REMARKS

The drawings, specification and claims are amended to correct informalities.

Drawings

FIG. 1A
(Prior Art)

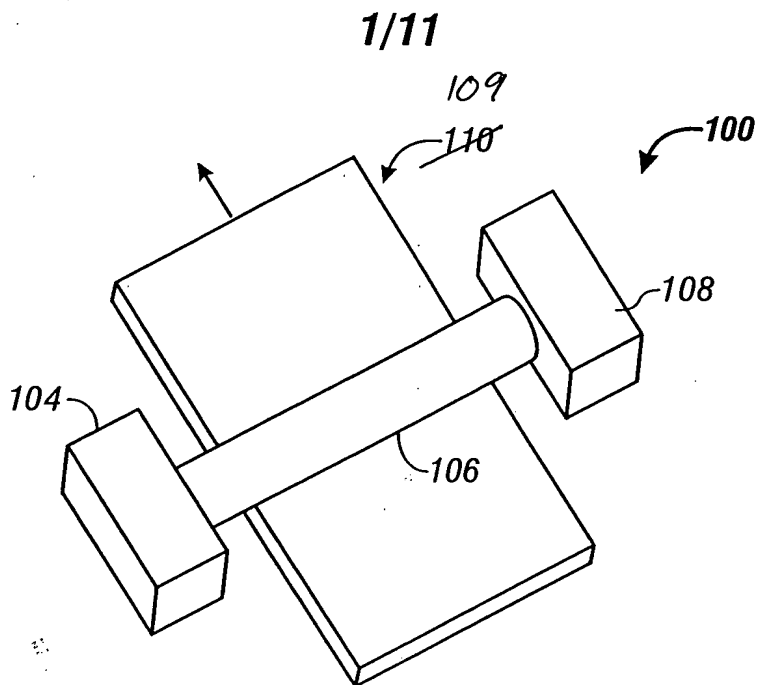
FIGURE 1: Glass sheet 110 in Figure 1A is relabeled as 109 in order to avoid conflict with target tube 110 of Figure 2. The text is amended in paragraph 0003 to reflect this change. Reference sign 130 is added to Figure 1B.

The specification is amended at paragraph 0003 to replace “glass sheet 110” with “glass sheet 109.” This is to avoid conflict with “target tube 110” shown in Figure 2. Figure 1A is also amended to replace “110” by “109.” Paragraph 0003 is also amended to reflect the correct spelling of the reference author “Russell J. Hill.”

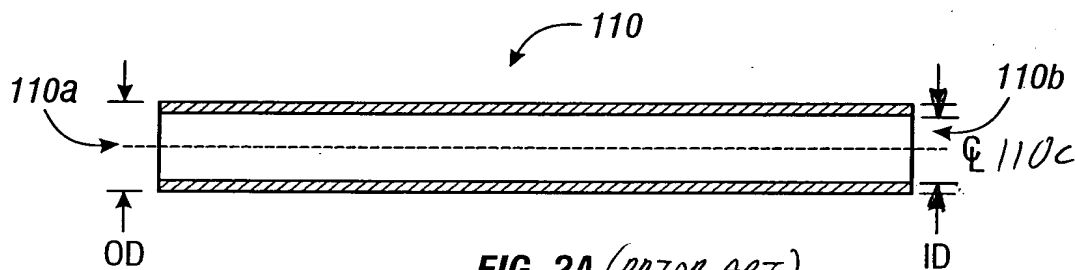
FIGURE 2: Figures 2A-2D have been modified to add "Prior Art" to each drawing. Reference sign 110c is added to Figure 2A. The arrows indicating "ID" have been moved to clearly show the inner diameter of target tube 110.

FIG. 3

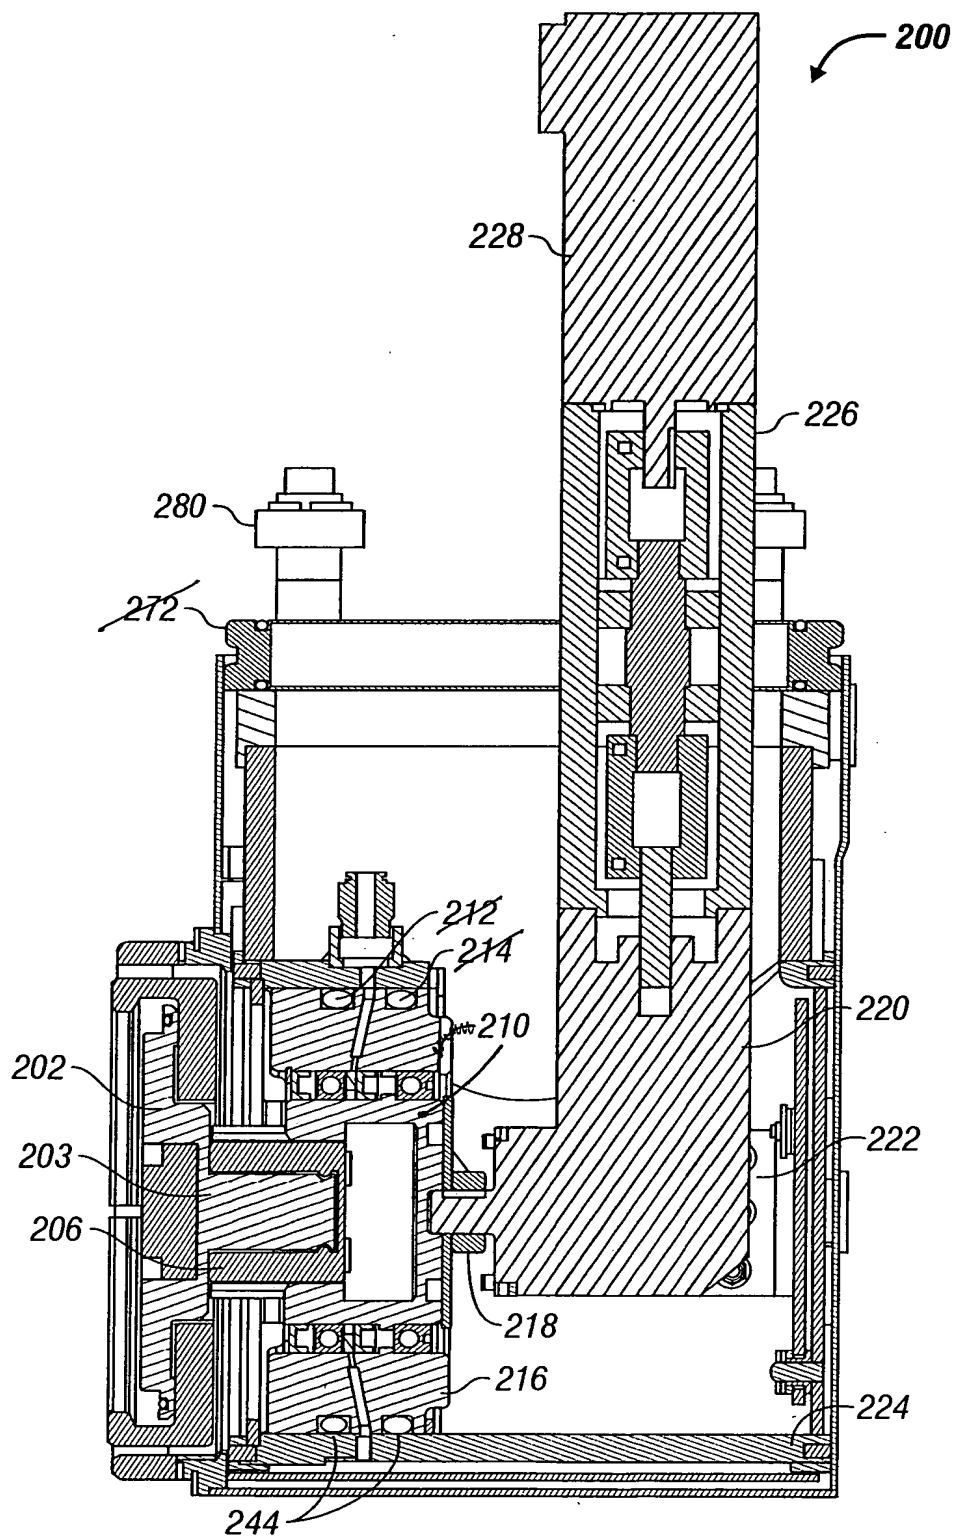
FIGURE 3: Reference signs 272, 212 and 214 are deleted. Reference sign 210 is amended to clearly indicate the correct part as shown in other figures such as Figure 5.

FIG. 4

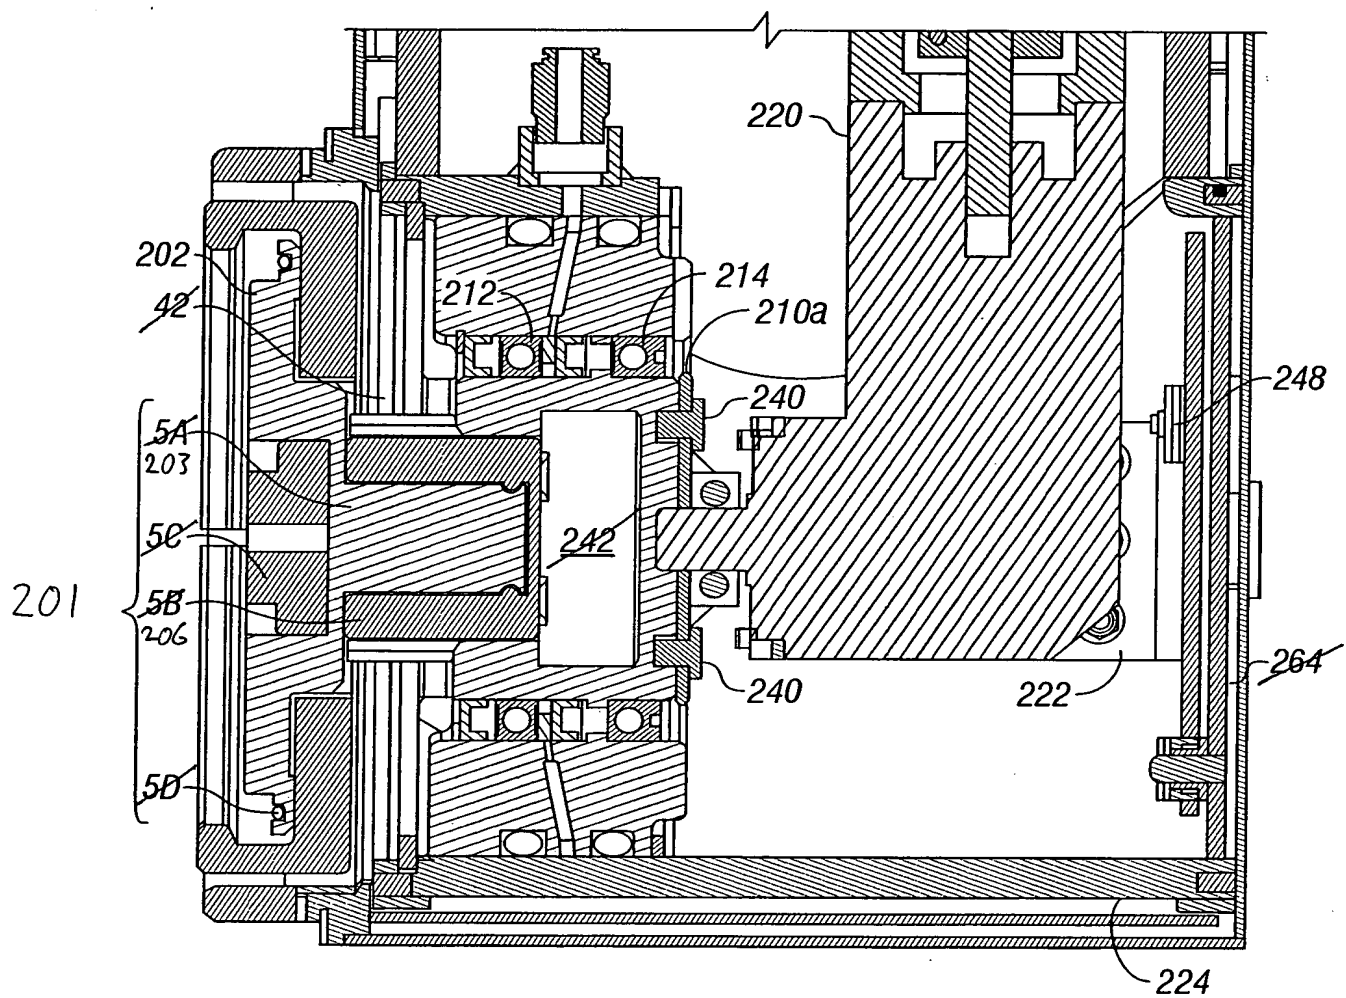
FIGURE 4: References 5A-5D of Figure 4 are deleted or amended to conform to the numbering used in other figures and to illustrate the components of reference 201. Reference signs 42, 242 and 264 are deleted. Reference sign 201 is added to Figure 4 to indicate drive assembly 201 as shown in Figure 5.

FIG. 12

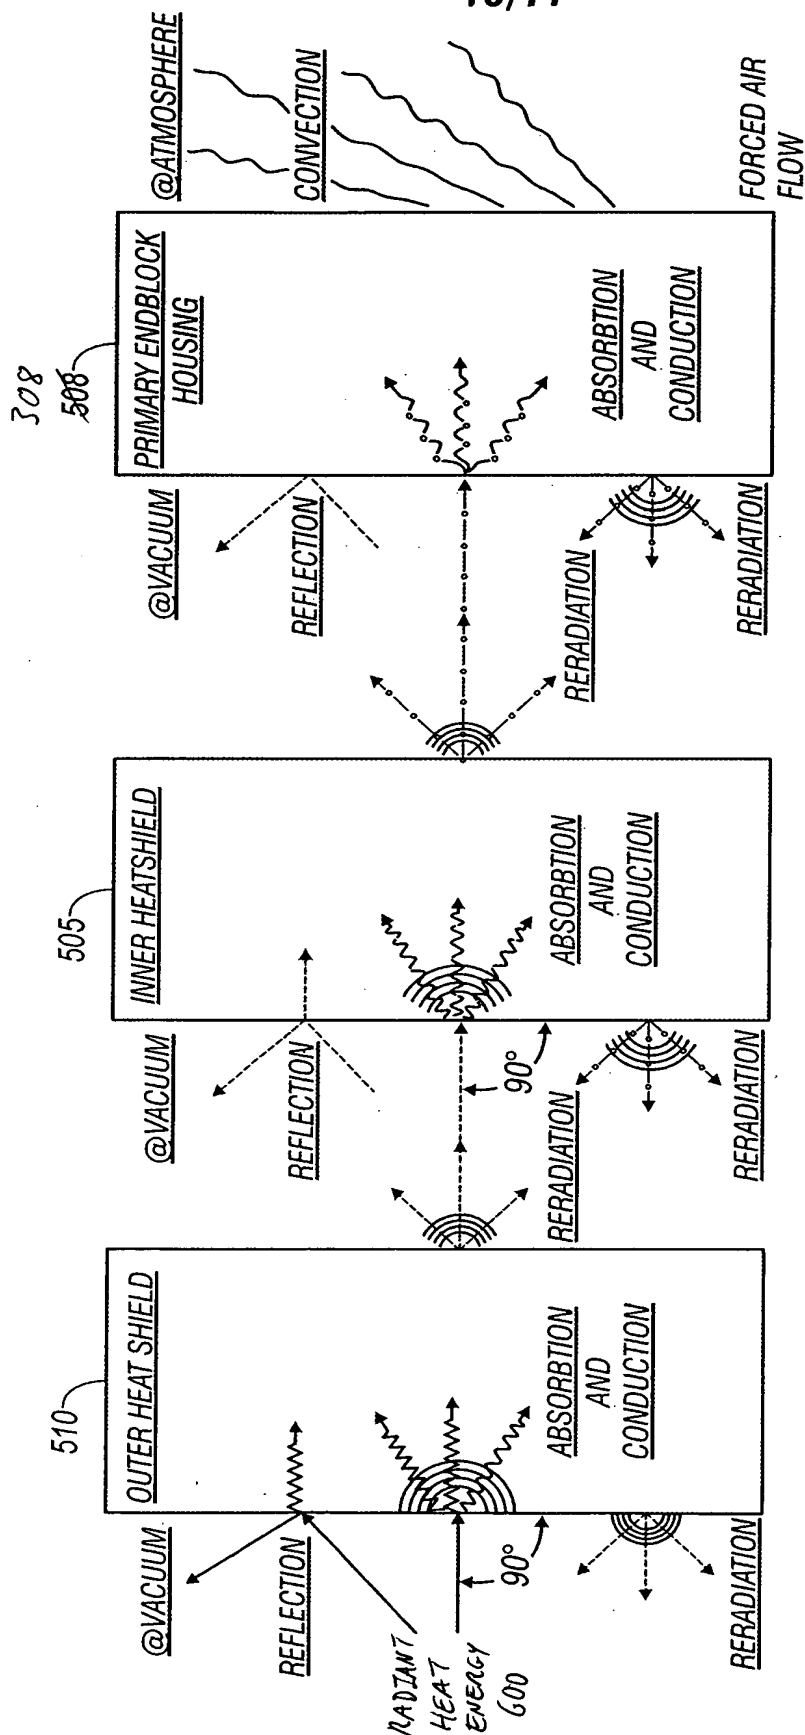
FIGURE 12: “Radiant heat energy 600” is added. This element is supported in paragraph 0071 of the specification. “The radiant heat energy 600 from the process arrives at the left side of the page.” Reference sign 508 is changed to 308. The specification refers to “endblock housing 308.” See, for example, paragraph 0072.
